SOLICITATION AMENDMENT
MODIFICATION DE L'INVITATION

Title - Sujet Greenstone Building Fit-Up	
Solicitation No. - N° de l'invitation EW038-171054/A	Amendment No. - N° modif. 005
Client Reference No. - N° de référence du client DND EW038-171054	Date 2016-09-01
GETS Reference No. - N° de référence de SEAG PW-\$PWU-107-10836	
File No. - N° de dossier PWU-6-39120 (107)	CCC No./N° CCC - FMS No./N° VME
Solicitation Closes - L'invitation prend fin at - à 02:00 PM on - le 2016-09-14	Time Zone Fuseau horaire Mountain Daylight Saving Time MDT
F.O.B. - F.A.B. Plant-Usine: <input type="checkbox"/> Destination: <input checked="" type="checkbox"/> Other-Autre: <input type="checkbox"/>	
Address Enquiries to: - Adresser toutes questions à: Anthony, Mary	Buyer Id - Id de l'acheteur pwu107
Telephone No. - N° de téléphone (780) 237-7582 ()	FAX No. - N° de FAX (780) 497-3510
Destination - of Goods, Services, and Construction: Destination - des biens, services et construction:

PROJECT TITLE
DND Office Fit Up - 3rd FLOOR
YELLOWKNIFE, NWT

DWG NO.
ASK
001

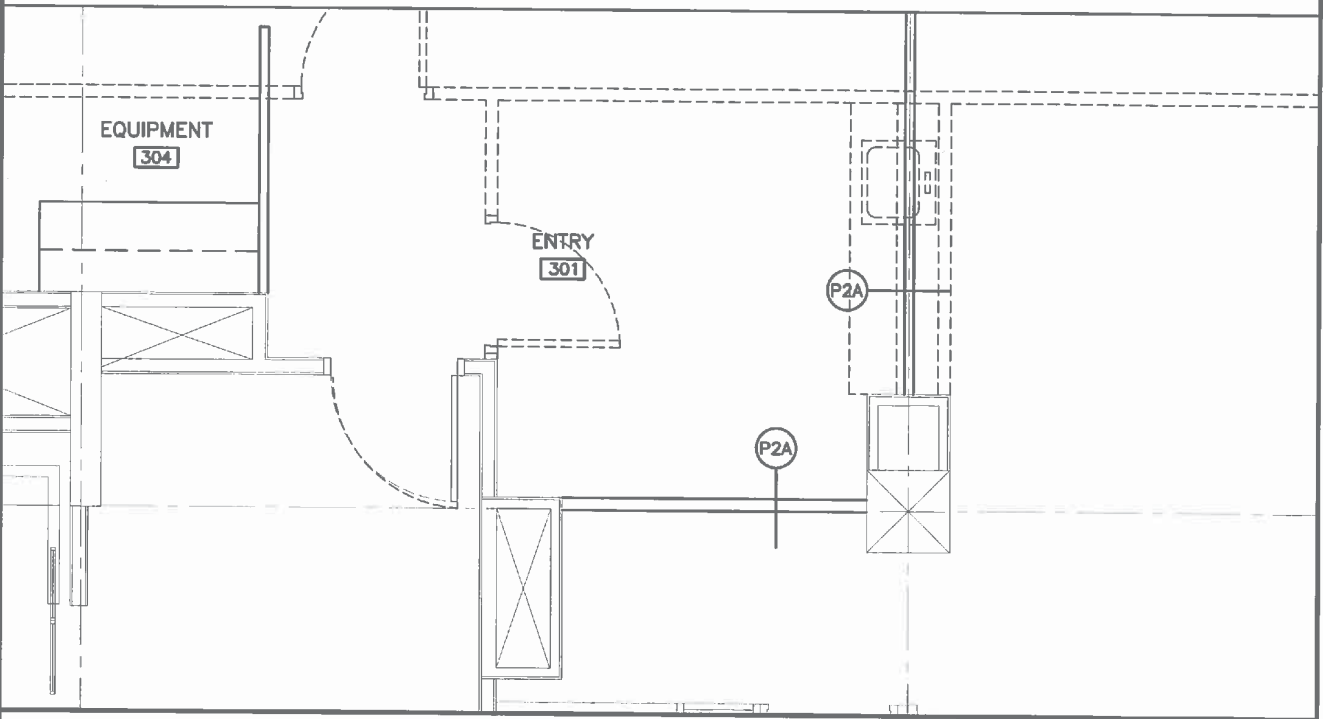
1.0	GENERAL	NOT USED
2.0	ARCHITECTURAL	
.1	Subject: Refer: Instructions:	Specifications Contract Documents - Section 08 71 10 Revise Headings 2, 5, & 13 as follows: provide lockset 3880-EU-RX-LM-ARC-US26D in leu of 3880xARC-US26D. Delete 2930 MORxUD26D. Provide power transfer 2-679-0623.
.2	Subject: Refer: Instructions:	Specifications Contract Documents - Section 09 21 16 Refer to Sheet A06 Partition Types: Section 09 21 16, Clause 2.1.1, vinyl-faced gypsum board to be used on all partitions. Revise partition notes to suit.
.3	Subject: Refer: Instructions:	Specifications Contract Documents - Section 09 99 70 Clarification to new carpet tile. New carpet tile to be installed on first floor only. Second and third floor to have existing carpet tile remain. Salvaged existing carpet tile to be used to replace discoloured carpet tile. Estimate of replacement is 15 to 18 tiles.
.4	Subject: Refer: Instructions:	Drawings Contract Documents - Sheet A03, 3 rd Floor Partial Floor Plan Revise Workstation Area 303 floor plan as indicated on ASK 01
